San Onofre Nuclear Generating Station
Unit 1

RESPONSES TO NRC REQUEST FOR
INFORMATION, TURBINE BUILDING RESPONSE SPECTRA

Impell Report No. 01-0310-1451
Revision 0

July, 1985

DAMPING = .0200

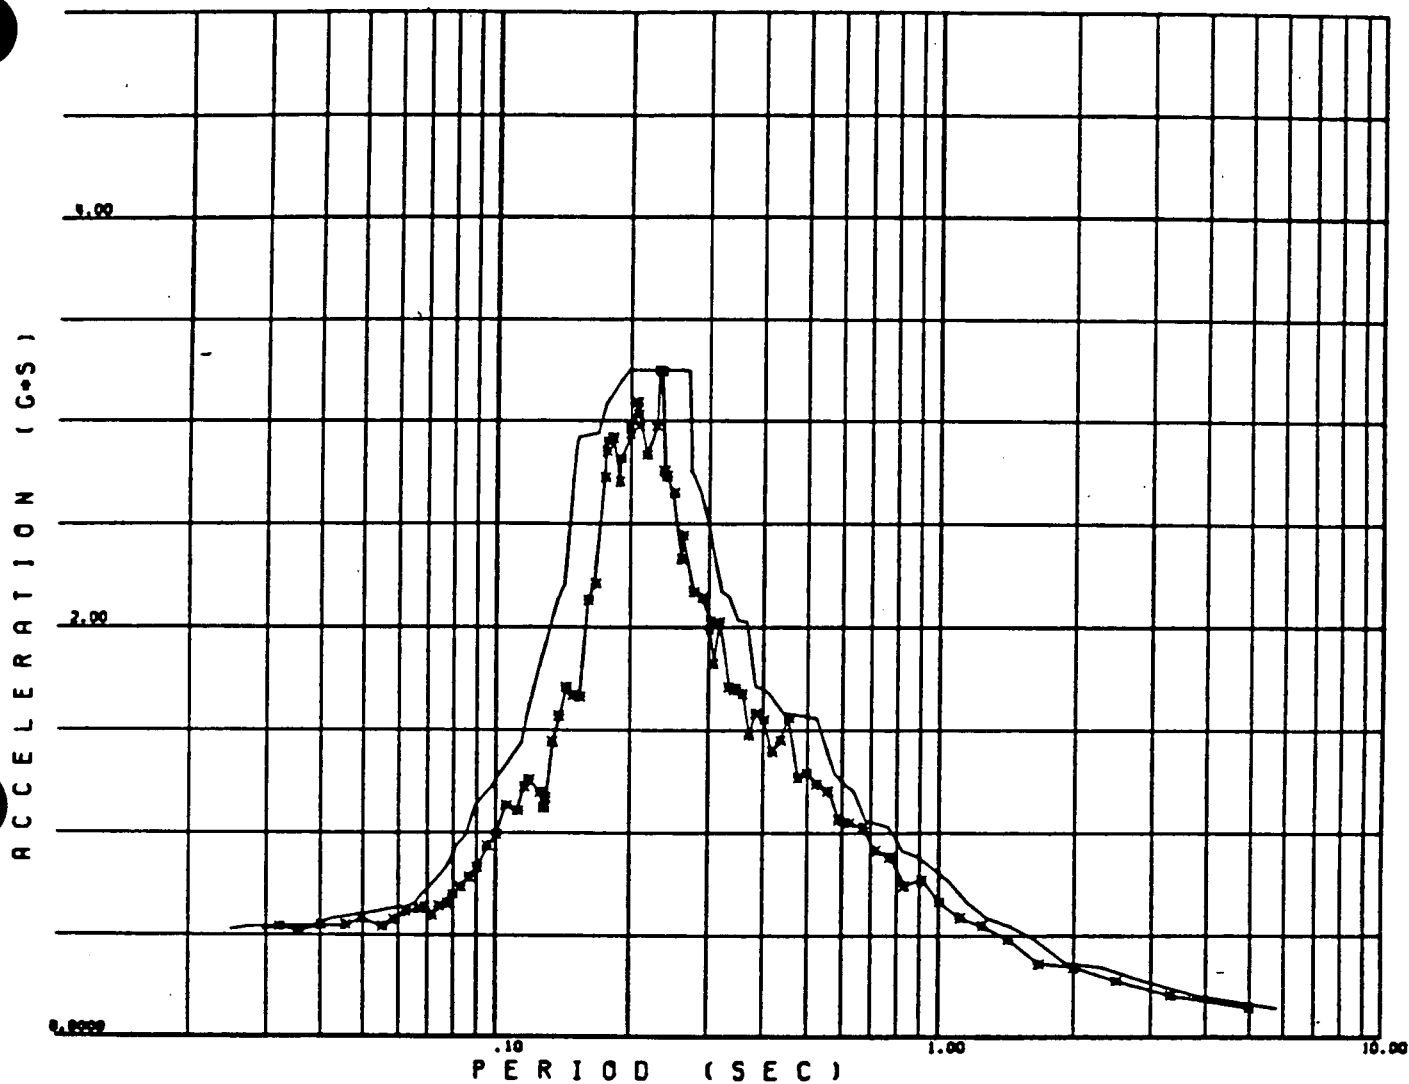
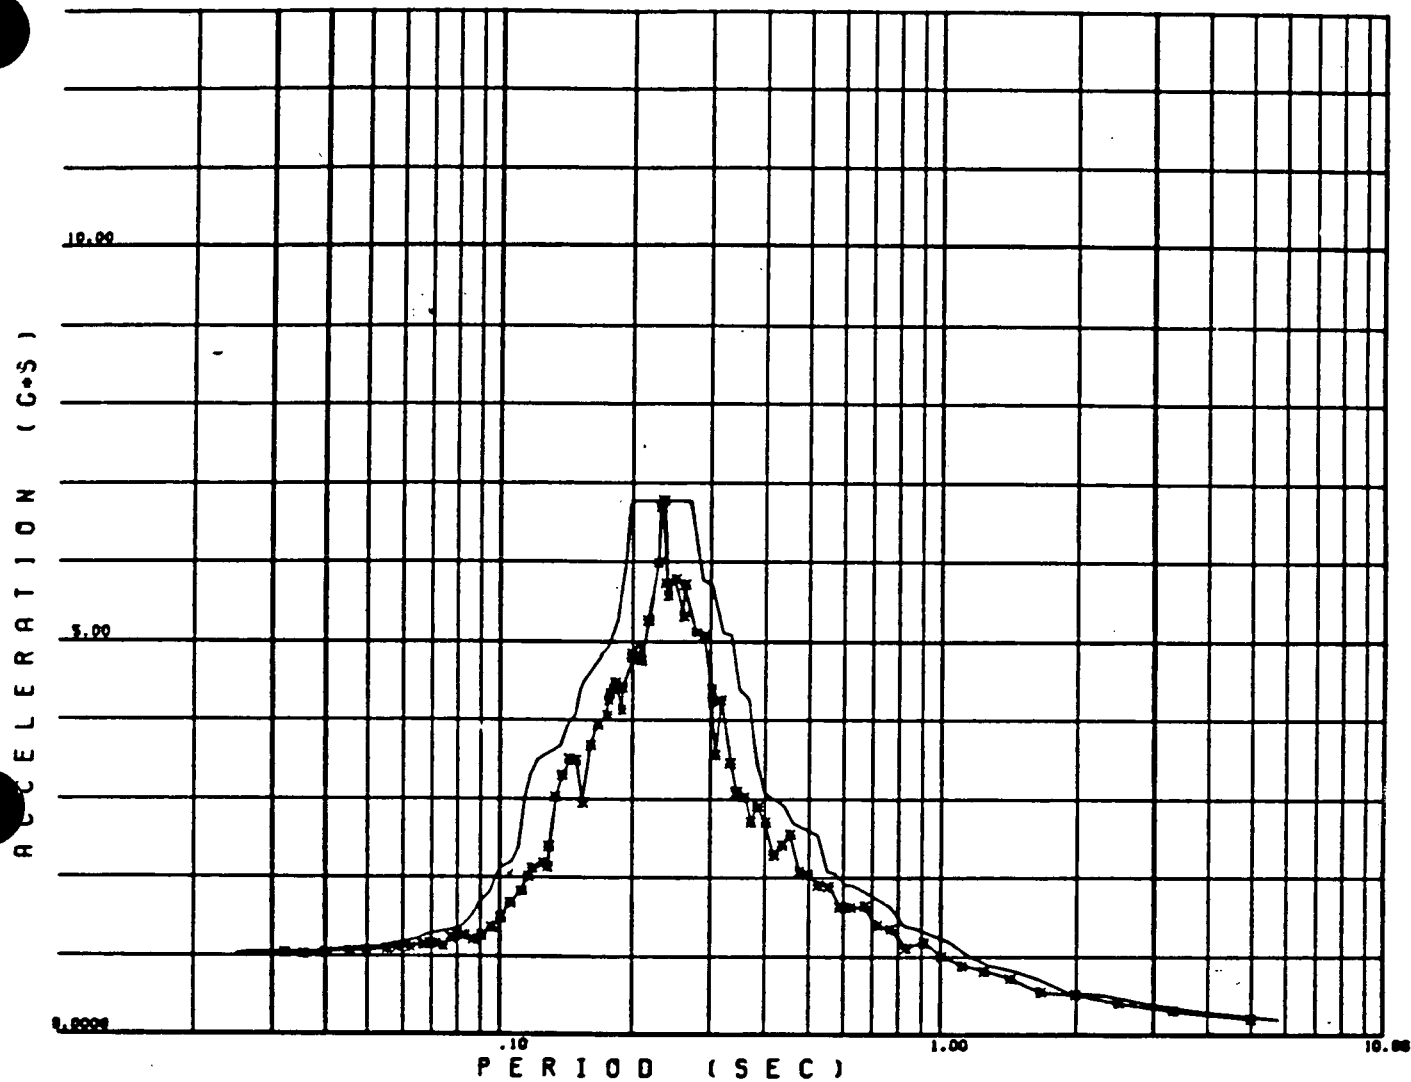
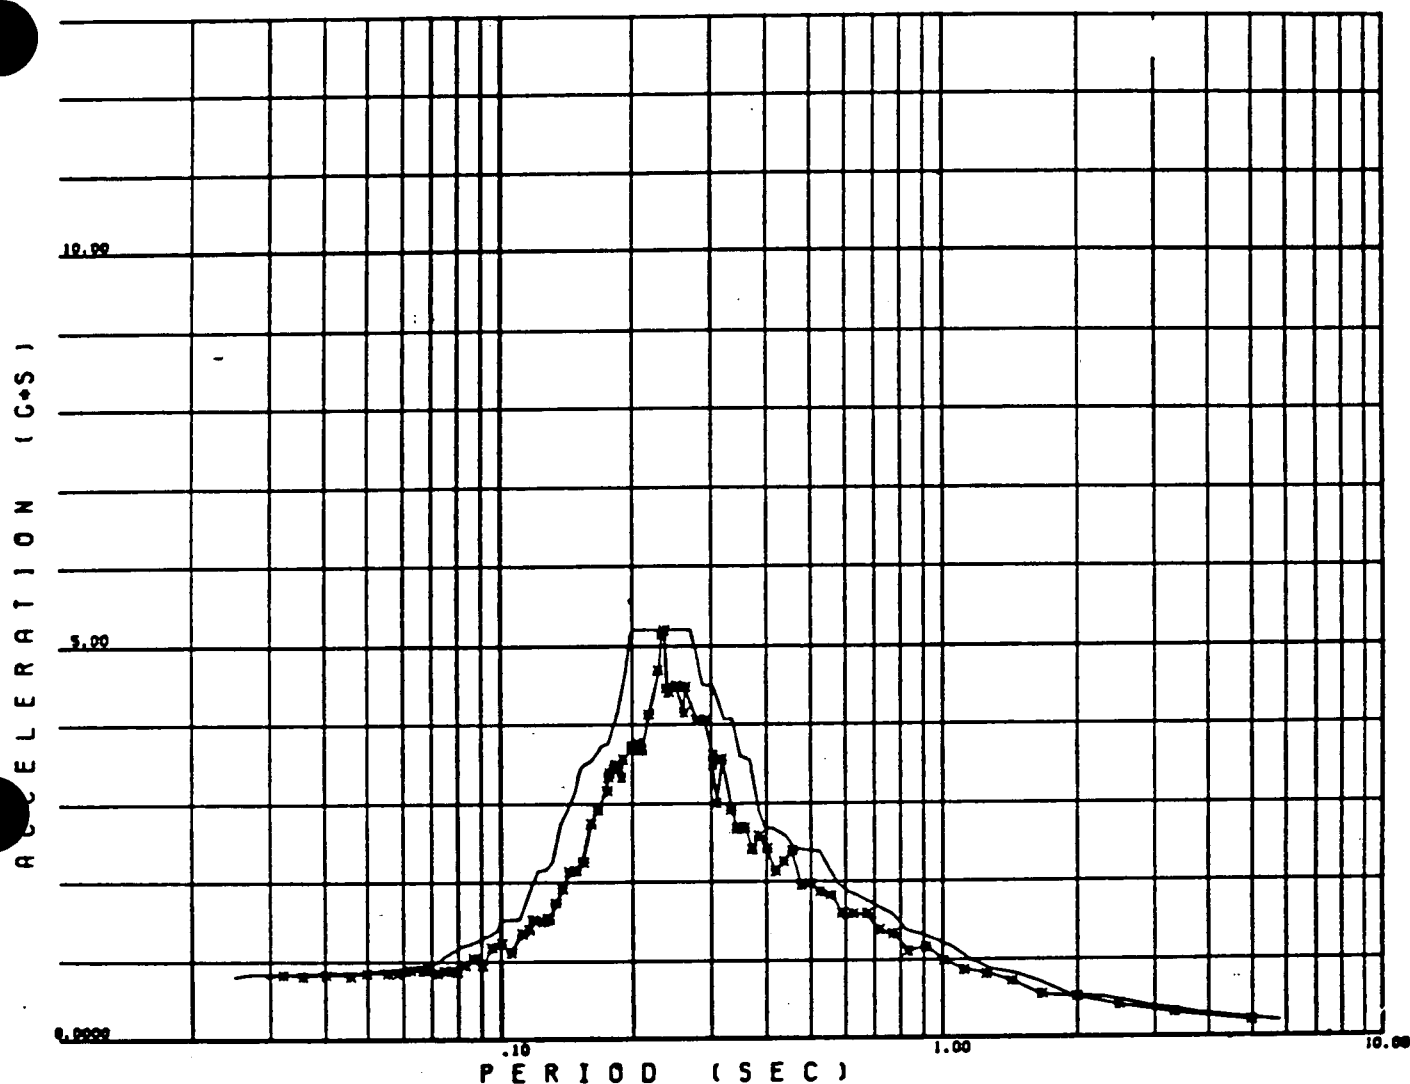
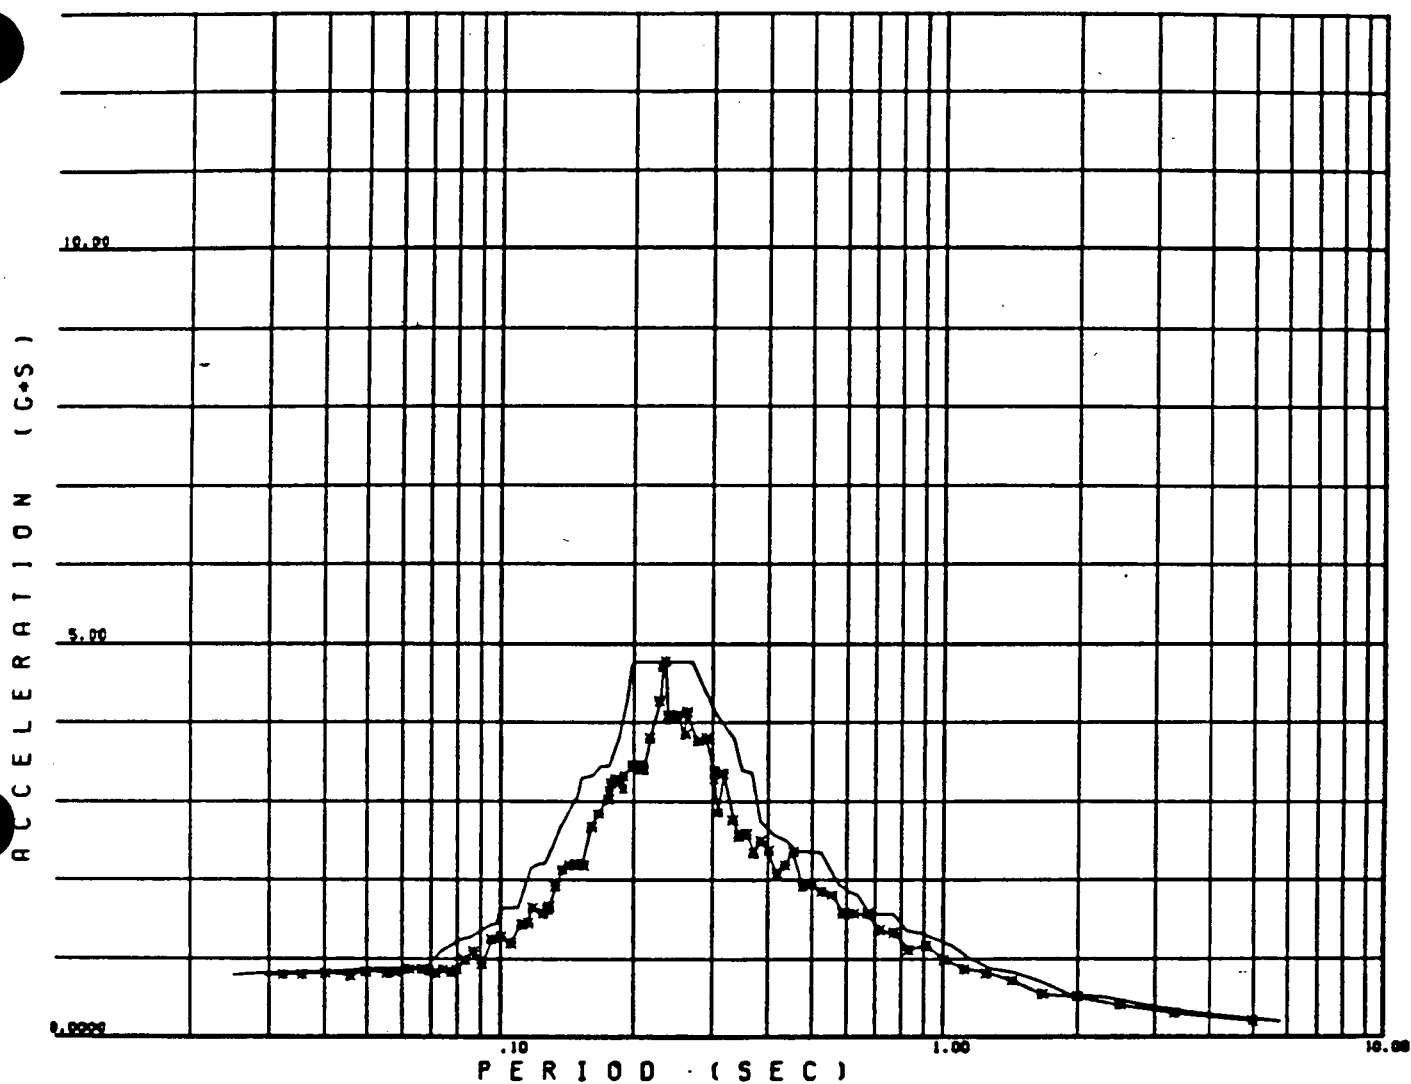
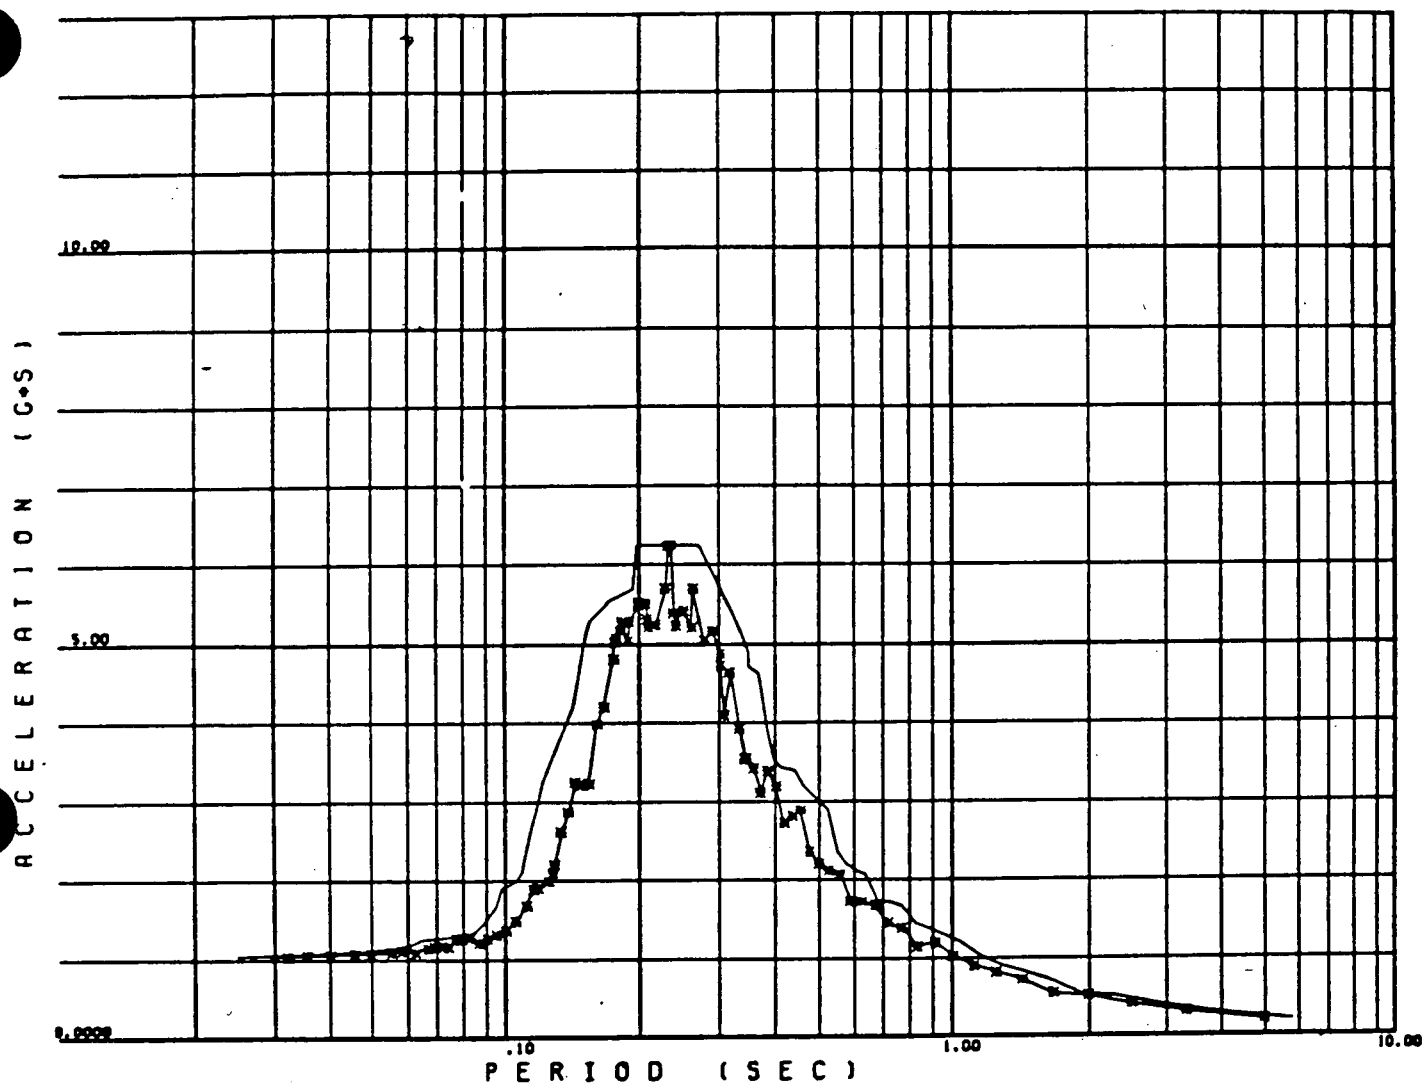
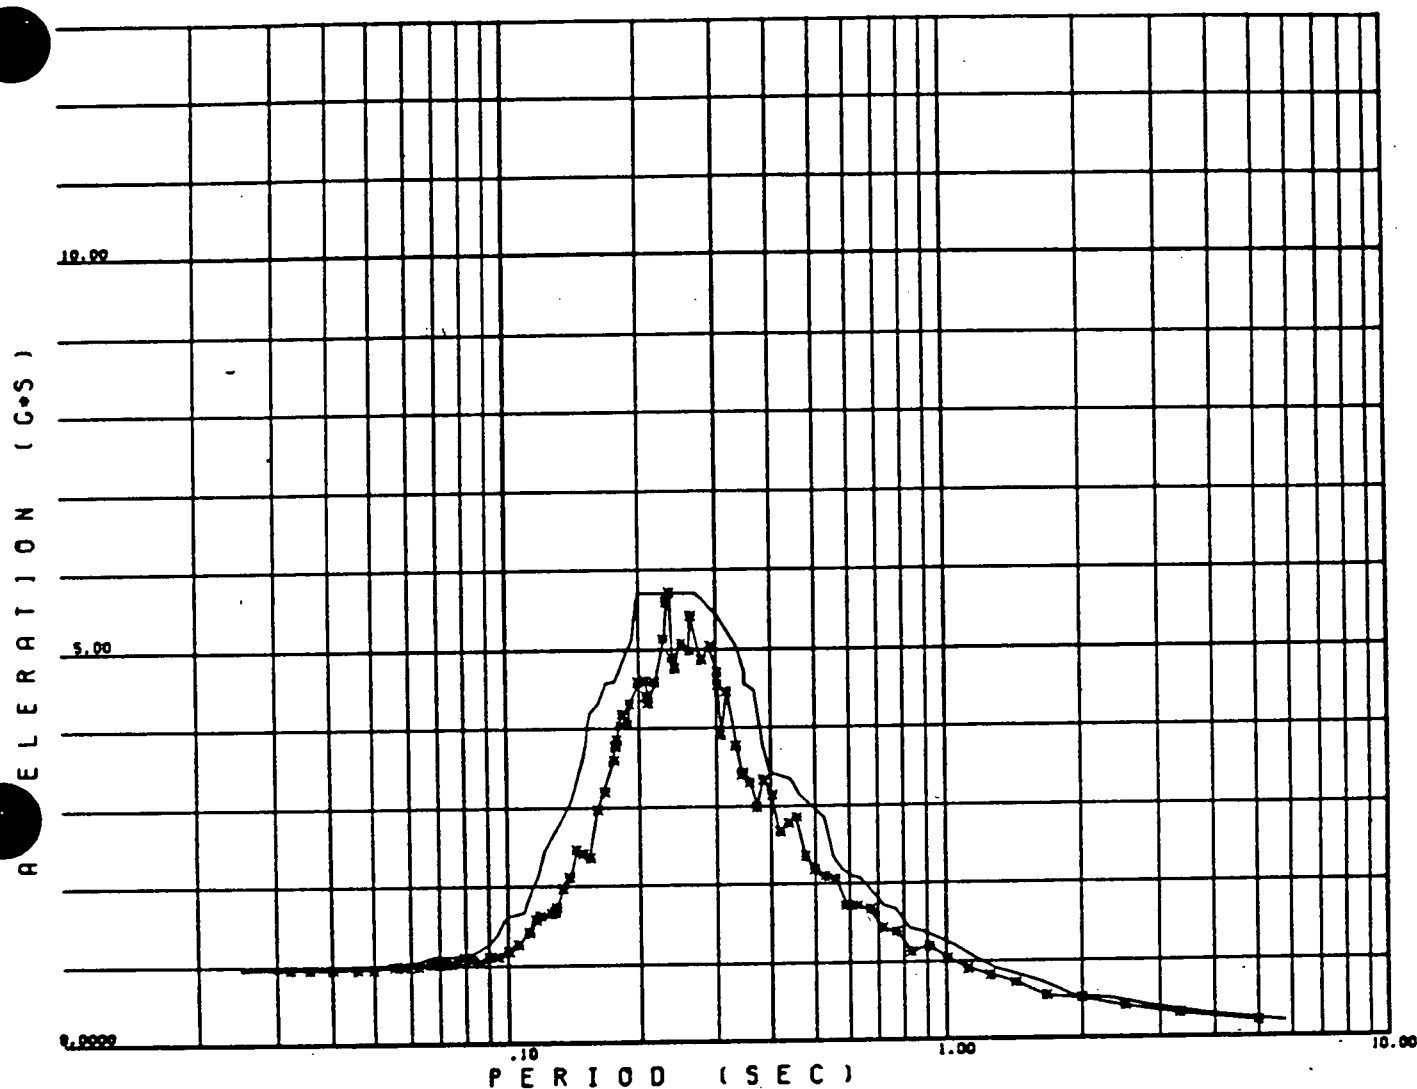
Provide comparison of Turbine Building floor response spectra with previous Bechtel spectra at two locations.

Raw response spectra, for 2% damping, generated by Impell and those generated by Bechtel are provided for the following locations:

- 1) Nodes 580, 586 and 610 in Area 2, North Extension, Elev. 42.0' for North-South Direction.
- 2) Nodes 29, 71 and 86 in Area 6, West Heater Platform, Elev. 35.0' for East-West and Vertical directions.
